## Certified Action of the City of Raleigh Planning Commission

**Case File / Name:** SP-45-12 / BB&T Litchford Road

## Staff Report

SP-45-12 / BB&T Litchford Road – Preliminary Site Plan

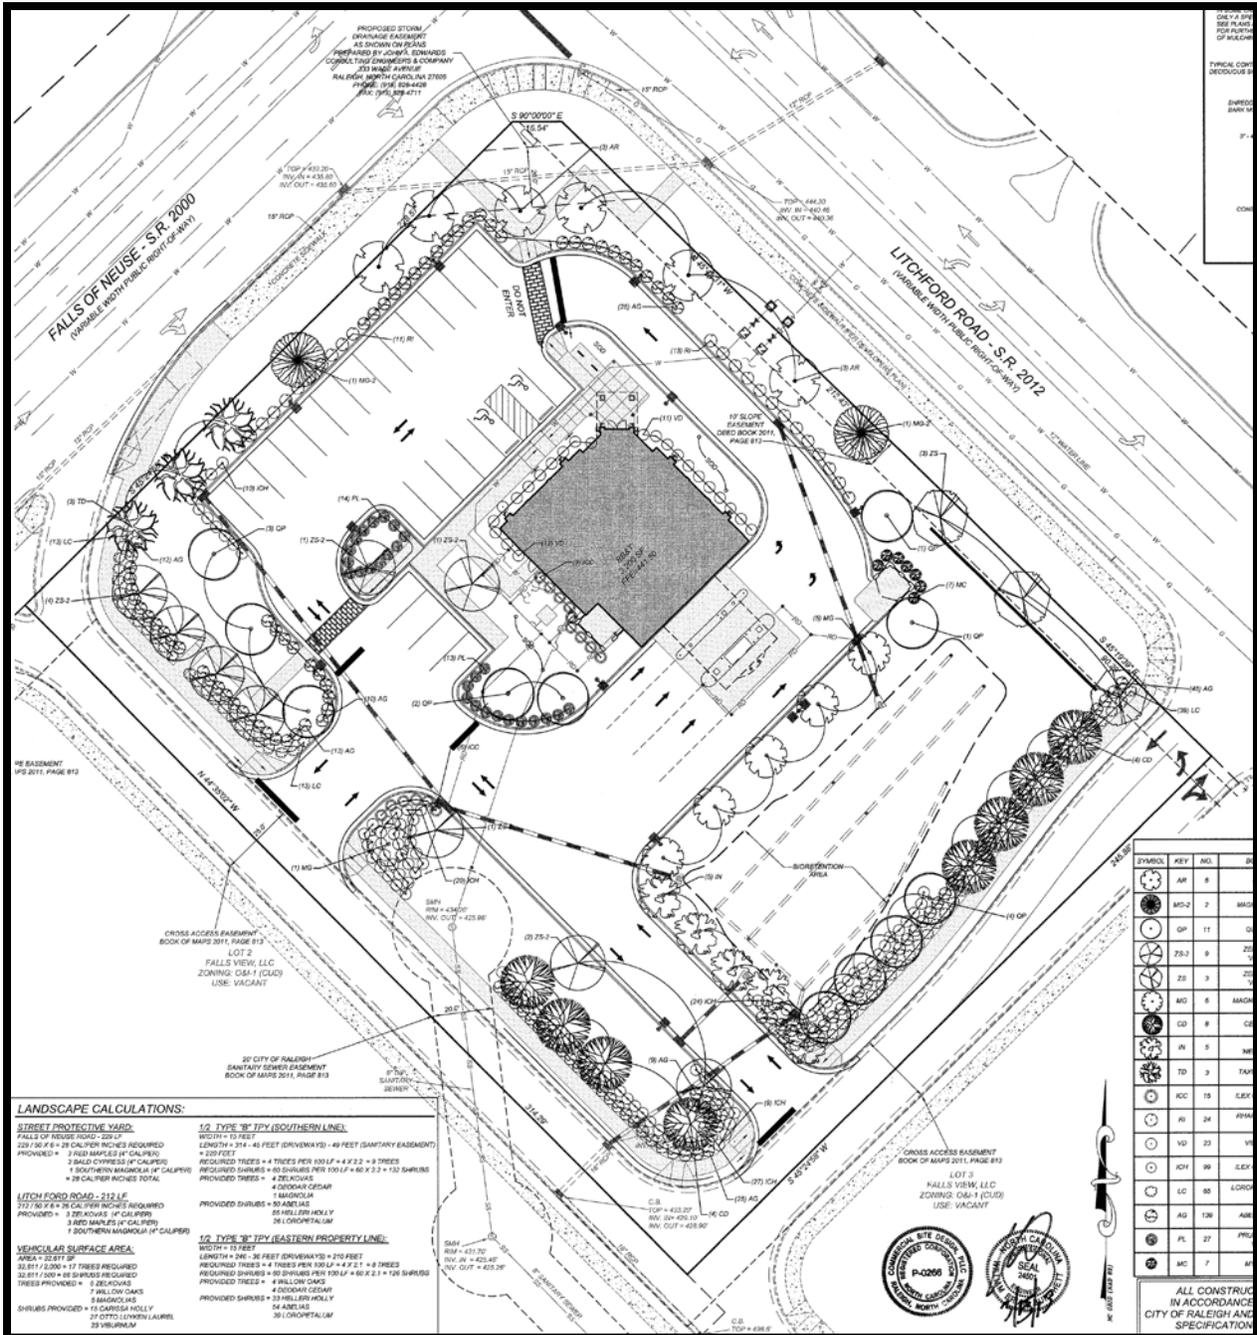
<u>Comment</u>	<u>Response</u>
1. The Commissions encourages applicant to add diversity to shrubs and plants.	We have now added ruby red loropetalum shrubs to the landscape plan to add species diversity as requested.

2. The Commission is concerned with crosswalk safety issues. The Commission suggests material or surface change to promote safety.	All crosswalks on the site are now shown to either be stamped concrete or brick pavers to promote safety.

3. The Commission recommends applicant use a more durable material on gable ends instead of EFIS, like a cementitious material.	BB&T proposes to keep the EIFS gable ends as this material matches the material, color and texture of the project that the Commission previously approved on Six Forks Rd. This will create a consistency between BB&T buildings as mentioned in Comment #4. BB&T would consider using a reinforcing mesh to make the material more durable.

4. The Commission suggests changing the look of tower feature to resemble other BB&T buildings. The tower features shown on plans looks similar to other architectural elements used by franchised buildings.	The tower feature is similar to that of the project that the Commission previously approved on Six Forks Rd. This will create a consistency between BB&T buildings. The main difference is the hip roof on the tower as required by the zoning conditions.
